7.2 KENT ROAD SEPARATED BICYCLE LANE OPTIONS

REPORT

Kent Road – Option 1
(Minimum width bi-directional separated bike lanes and physical separator)
 (Looking East)

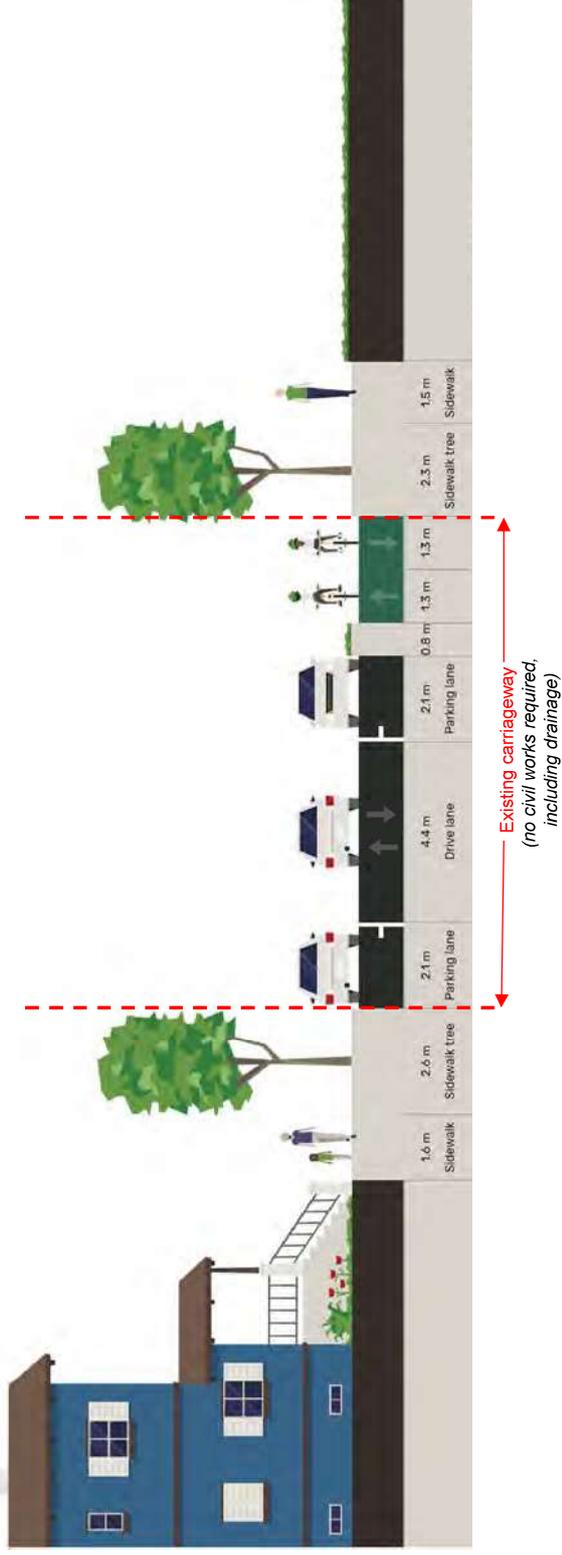
- a) The current design is considered, on balance a well-performing option suitable to continuation of a trial with minor amendments.
 - b) Option one (minimum width bi-directional separated bike lanes and physical separator) and option three (widening of the south side footpath to allow for bikes and footpath off road) meet design considerations but are not suitable for trial implementation as they require detailed design at the Cumberland Road roundabout including footpath realignment into the park and Department of Transport approval.

Bi-directional, 2.6m cycle lane on southern side. Removal of northern physical barrier. Reduction of southern barrier to 0.8m. Reallocation of 1.4m to driving lanes. This is slightly less than the existing vehicle carriage way of Kent Road east of Cumberland Road (8.6m here vs 9.0m on average for Kent Road east of Cumberland Road).

Kent Road – Option 2
Bike lanes max 1.2m with plastic bollards as separators
 (Looking East)

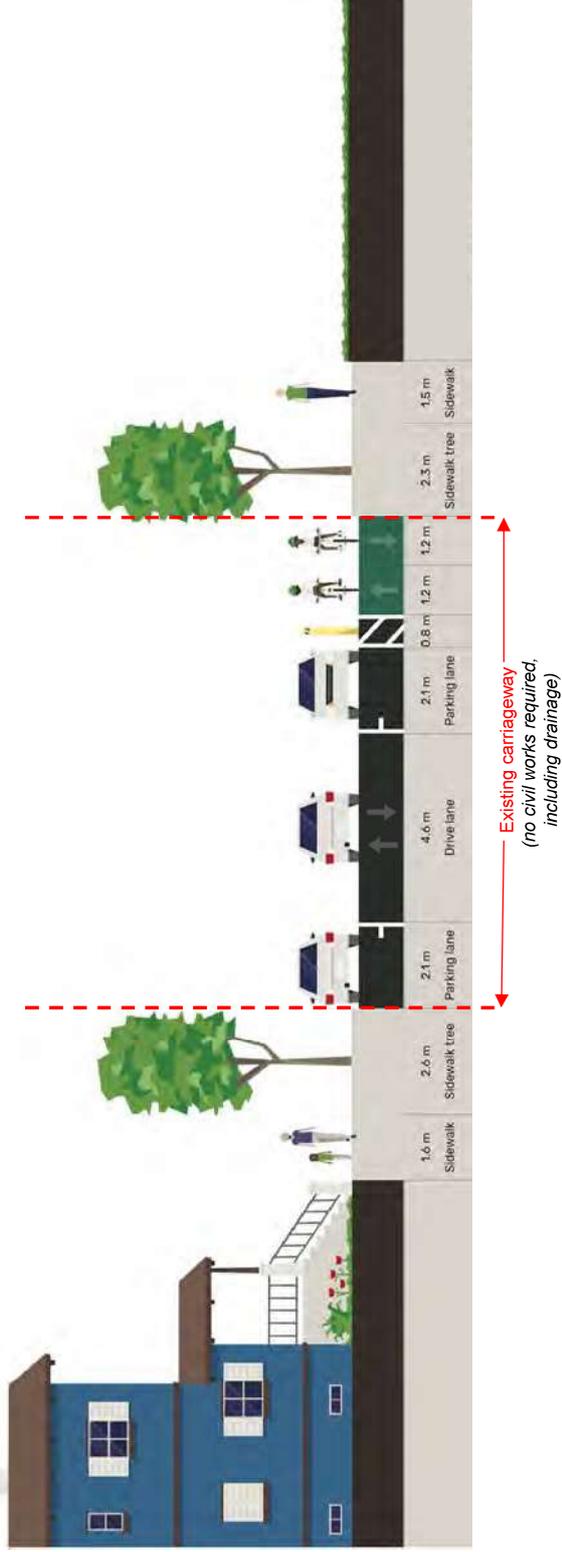
- c) Option two (bike lanes max 1.2m with plastic bollards as separators) provides insufficient bike lane width and is considered unsafe for either a trial or permanent street-cross section design for Kent Road.

Removal of northern physical barrier. Reduction of southern physical barrier to 0.8m. Bi-directional, 2.4m cycle lane on southern side (insufficient operating width). Reallocation of 1.6m to driving lanes. This is slightly less than the existing vehicle carriage way of Kent Road east of Cumberland Road (8.8m here vs 9.0m on average for Kent Road east of Cumberland Road).

Kent Road – Option 3
Widening of the south side footpath to allow for bikes and footpath off road
 (Looking East)

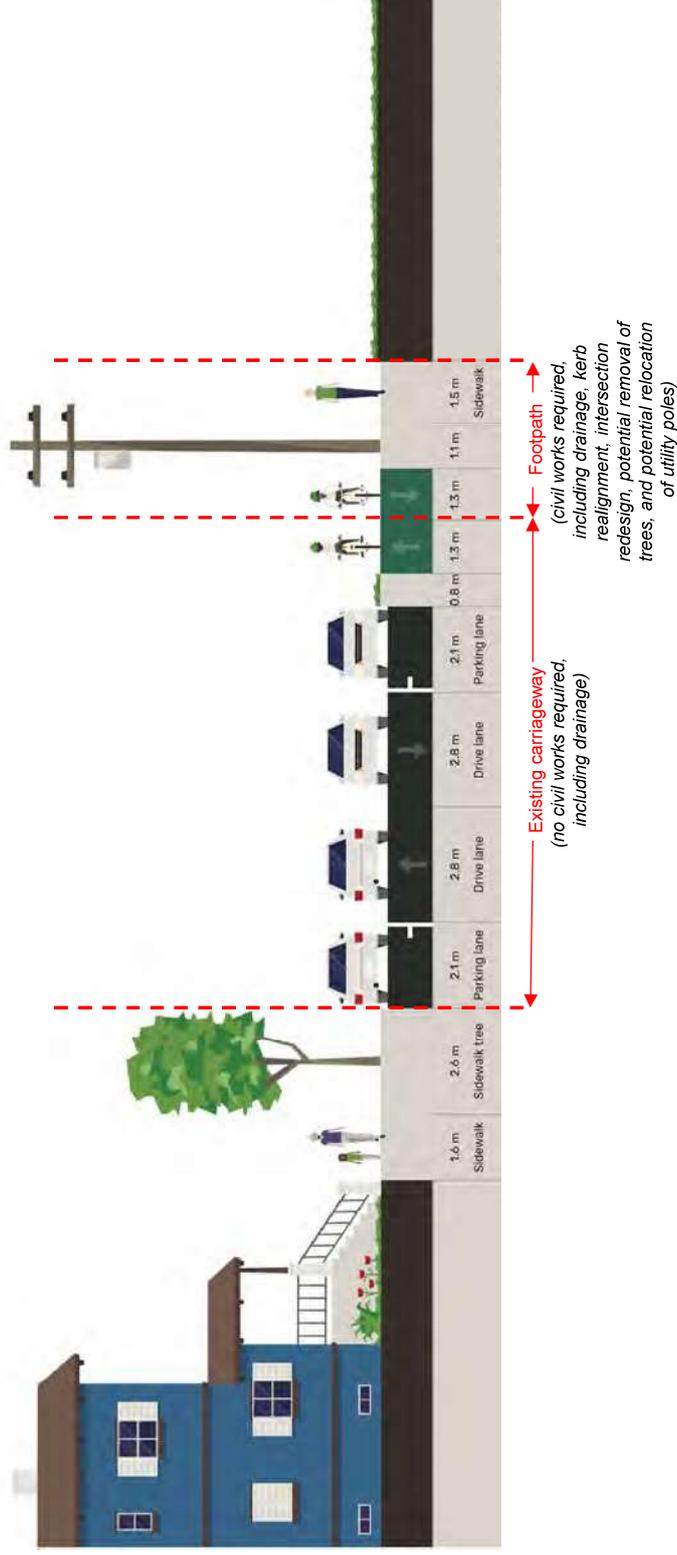
Bi-directional, 2.6m cycle lane and 1.5m footpath on south side. Reduction of physical barrier to 0.8m. Removal of northern physical separator, 9.8m road carriageway facilitating two-way vehicle movement and parked cars. Significant civil works to relocate southern curb alignment and utility poles. Removal of trees on southern side. Detailed design required.

Kent Road – Option 4
Widening of the south side footpath to allow shared path
 (Looking East)

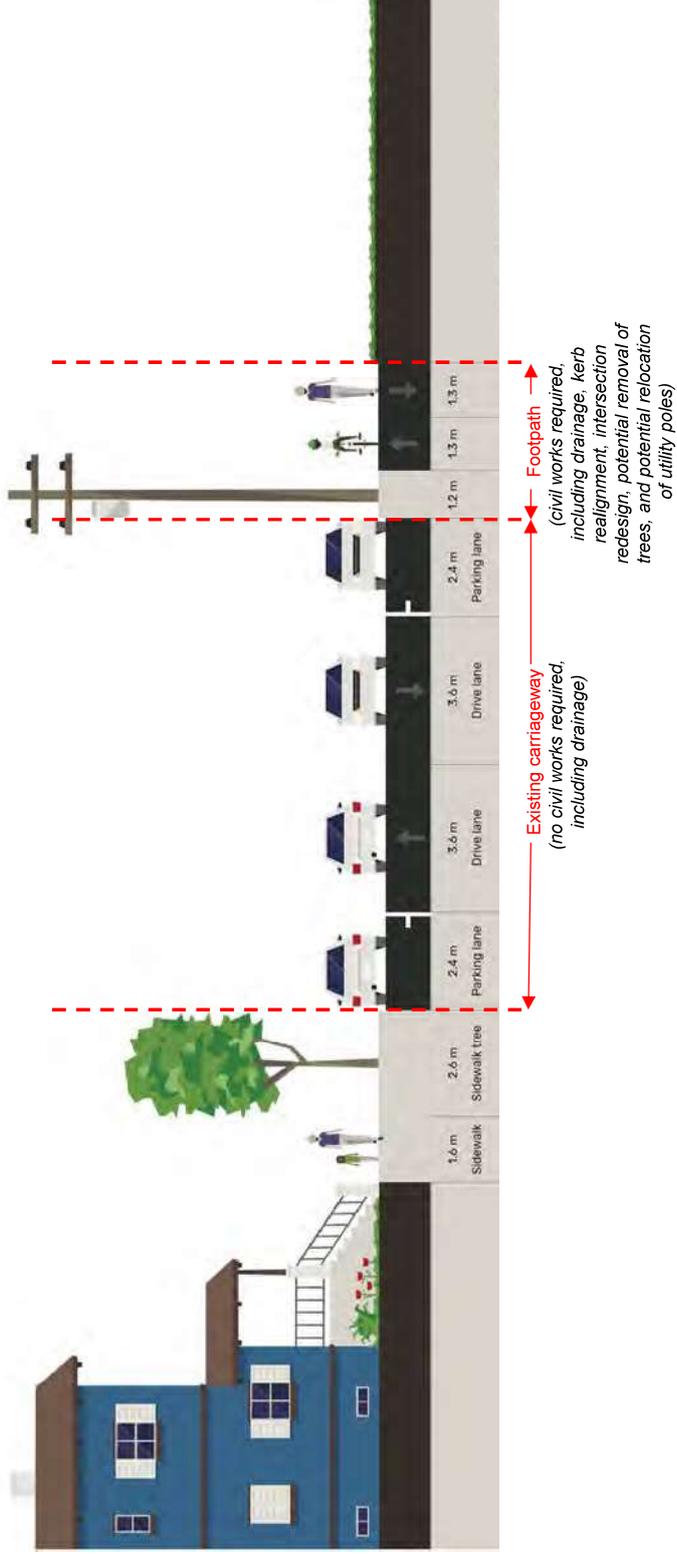
- d) Option four (widening of the south side footpath to allow shared path) is considered unsafe for either a trial or permanent street-cross section design for Kent Road due to the inherent issues with shared paths.

Bi-directional, 2.6m shared path. Unsafe for pedestrians and cyclists on southern shared path. Removal of all physical barriers. Vehicle carriageway returned to pre-June 2021 conditions. Significant civil works to relocate utility poles. Removal of trees on southern side. Detailed design required.

Kent Road – Option 5
Similar to current trial but removes physical concrete separator and replaces with 0.8m plastic bollard treatment
Looking East

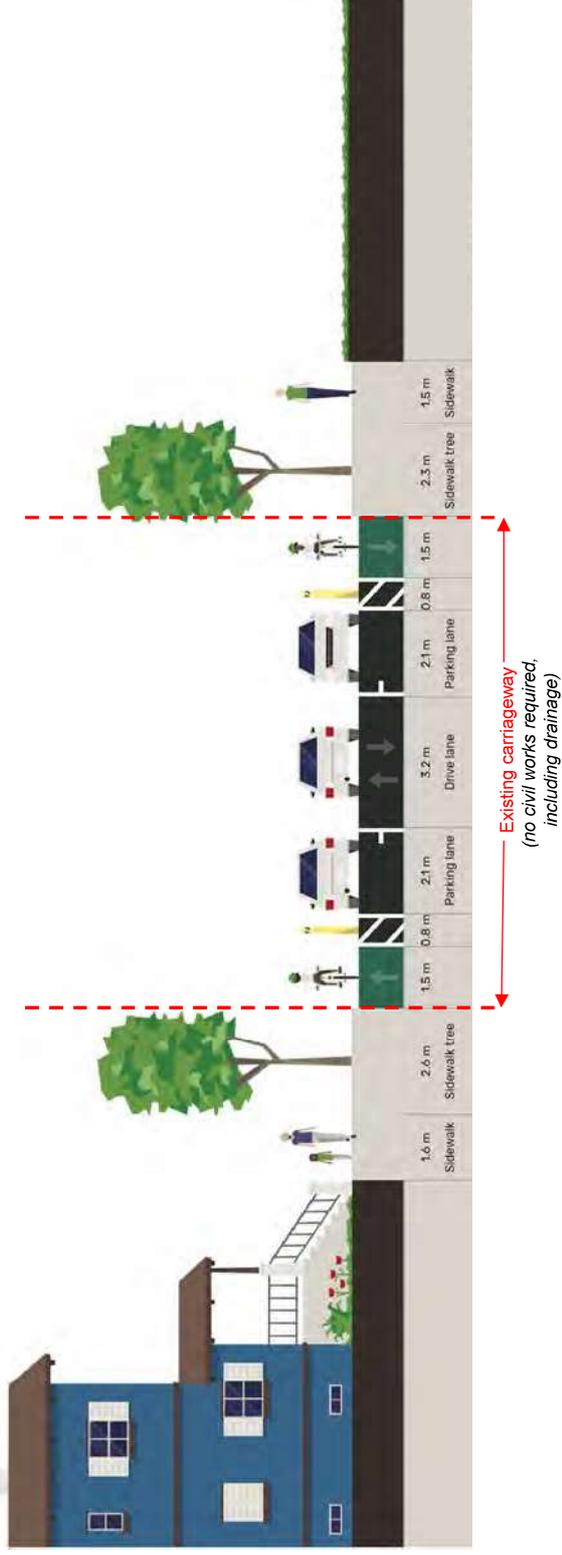
- e) Option five (similar to current trial but removes physical concrete separator and replaces with 0.8m plastic bollard treatment similar to Northumberland Road) is a minor adaptation to the current design which delivers improvements to pedestrian walkability, future street waste collection and marginal improvement to vehicle operating widths and turning circles for driveways.

Reduction of physical separators to 0.8m. Reallocation of 0.2m to vehicle carriageway. Trial of temporary traffic bollards and painted lines as physical separator to improve walkability.

Kent Road – Option 6 Removal of parking on southern side and reduction in width of physical separators

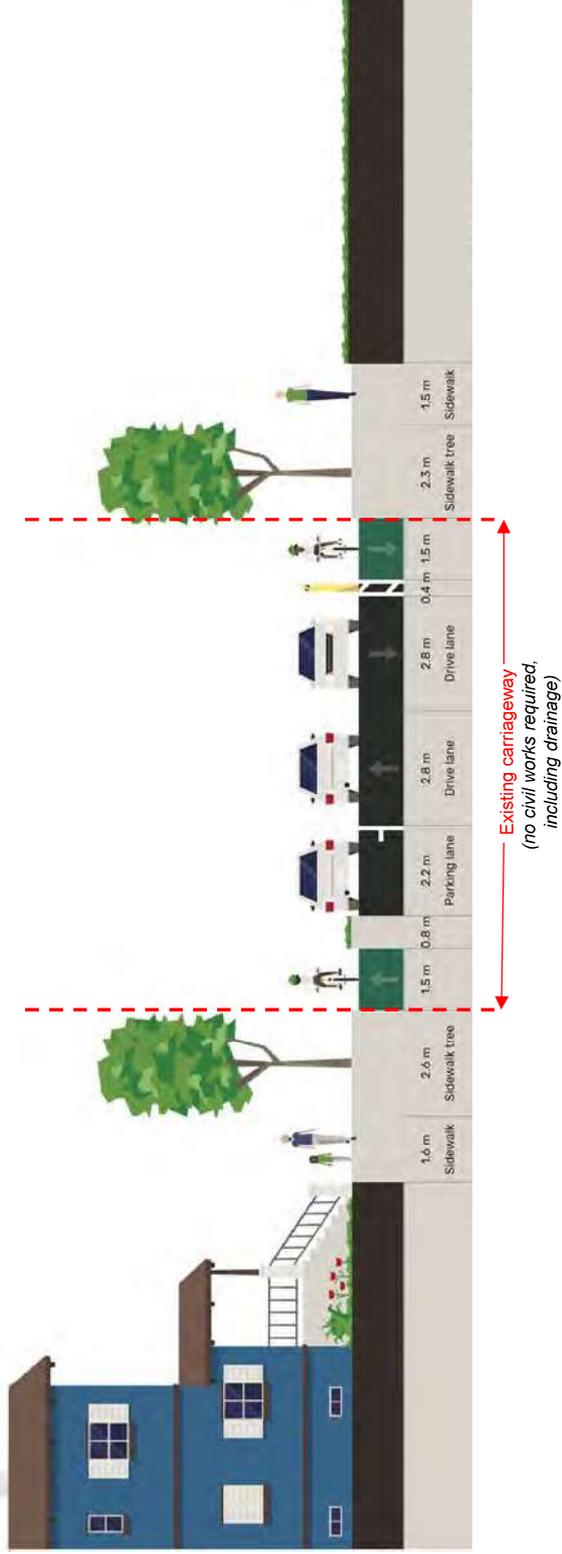
- f) Option six (removal of parking on southern side and reduction in width of physical separators) requires removal of on-street parking on the southern side of Kent Road and allocation of that road space to allow continuous two-way traffic flow in a low speed environment.

Removal of parking on southern side. Reduction of northern physical separator to 0.8m. Reduction of southern physical separator on southern side to 0.4m. Reallocation of 0.6m to vehicle carriageway.

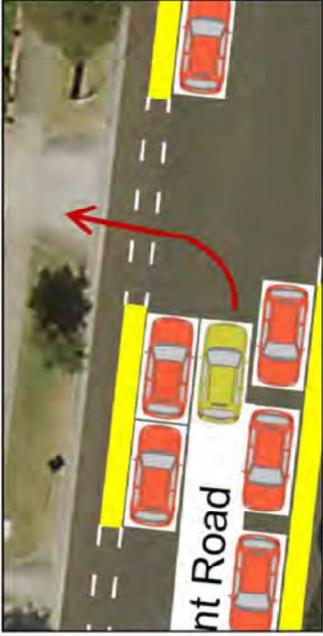
Audit Findings	Level of Risk	Safe System Energy	Recommendations P – Primary S – Supporting N – Non-Safe System ST – Step Towards	Accept Yes/No	Responsible Officer Comments
<p>a) Bike Lane Layout</p> <p>i. Sharrows and bicycle wayfinding pavement marking exists on Crowley Court on approach to Northumberland Road – indicating this is a local bicycle route. Yet cyclists turning from Crowley Court cannot access the protected bike lane on Northumberland Road as there is no break* at this location. Similarly, cyclists using the protected bike lane are unable to turn into Crowley Court. This could encourage cyclists to perform unsafe manoeuvres.</p> 	<p>Occasional Minor MEDIUM</p>	<p>Within tolerable levels</p>	<p>*This finding has been developed with the assumption that the protected bike lane will be separated by a continuous kerb / physical barrier. Consider providing a break in the protected bike lane to enable a cyclist exiting from Crowley Court to access the protected bike lane. (S) Consider encouraging cyclists wanting to access Crowley Court to use the wombat crossing. (S)</p>

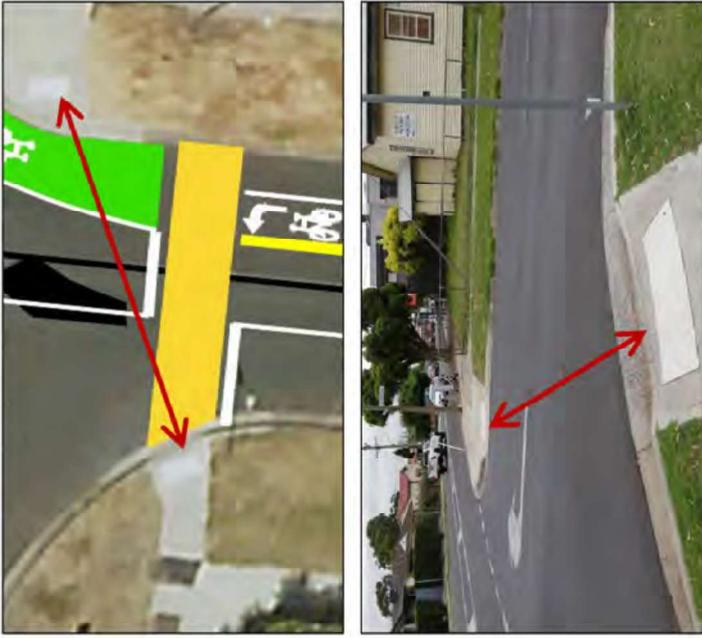
Audit Findings	Level of Risk	Safe System Energy	Recommendations P – Primary ST – Step Towards S – Supporting N – Non-Safe System	Accept Yes/No	Responsible Officer Comments
<p>ii. The entrance to Pascoe Vale Girls College crosses the proposed protected bike lane. This creates a conflict point between vehicles and cyclists.</p> 	<p>Improbable Minor LOW</p>	<p>Within tolerable limits</p>	<p>As this access leads to the school car park, it is expected there are a relatively large number of vehicles turning into and exiting this driveway. As such, it is recommended to install green conflict paint across the bike lanes to raise motorists' awareness of cyclists in the area. (S)</p>

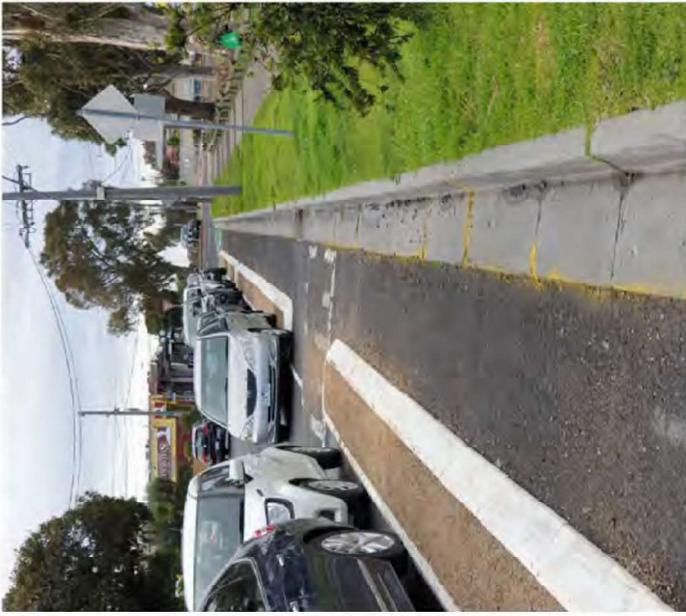
Audit Findings	Level of Risk	Safe System Energy	Recommendations P – Primary ST – Step Towards S – Supporting N – Non-Safe System	Accept Yes/No	Responsible Officer Comments
<p>a) Cycle path issues</p> <p>i) On the westbound bicycle path just east of Valerie St, there is a longitudinal groove on the path surface that may be hazardous to cyclists. Narrow bicycle wheels can get caught and tramline in this groove.</p>  <p>It appears to already have been identified as a hazard and highlighted with some yellow paint.</p>	<p>Probable Minor HIGH</p>	<p>Within tolerable limits</p>	<p>Consider resurfacing the path to remove these grooves (S)</p>
